Architect's Supplemental Instructions

Architect's ASI No: 043

Project:
Webster University
Interdisciplinary Science
Building

Date Issued: 12/20/2016

M0101.A

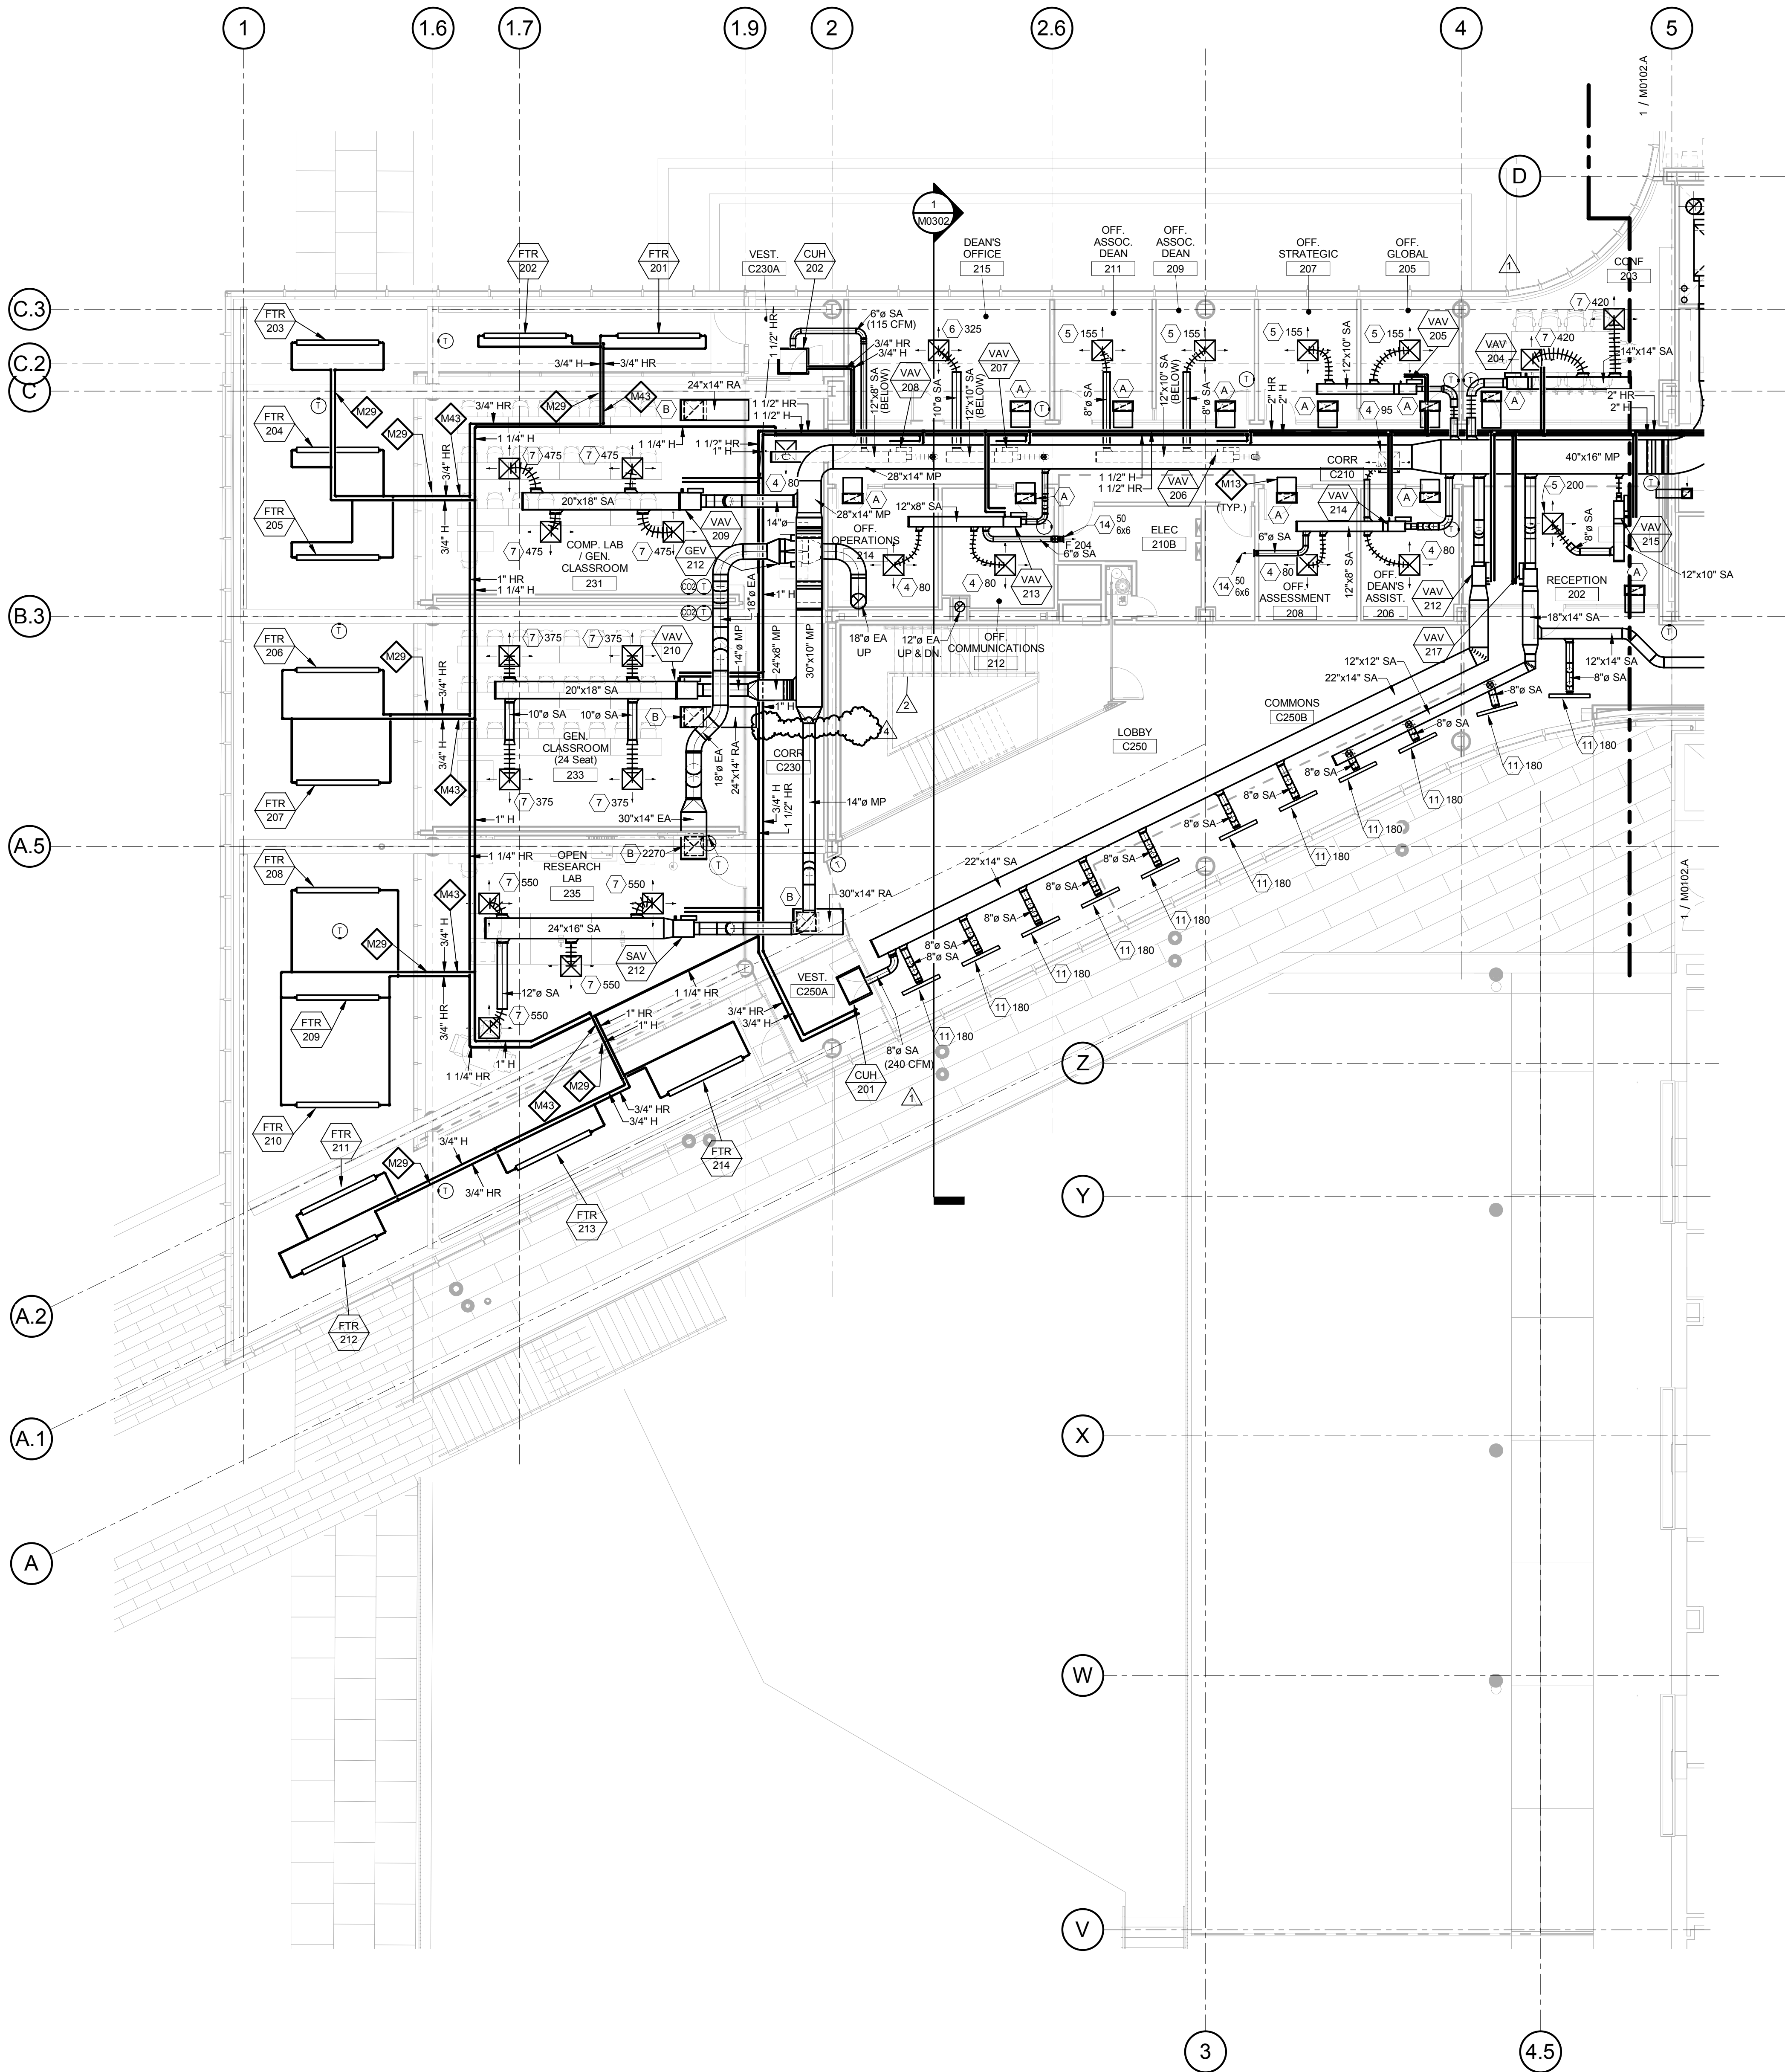
- Delete expensive heating hot water bypass valve and associated bypass piping from plan for cost savings.
- Delete Keyed Note M51: "1" HEATING HOT WATER BYPASS WITH BACKPRESSURE CONTROL VALVE (5 GPM)."
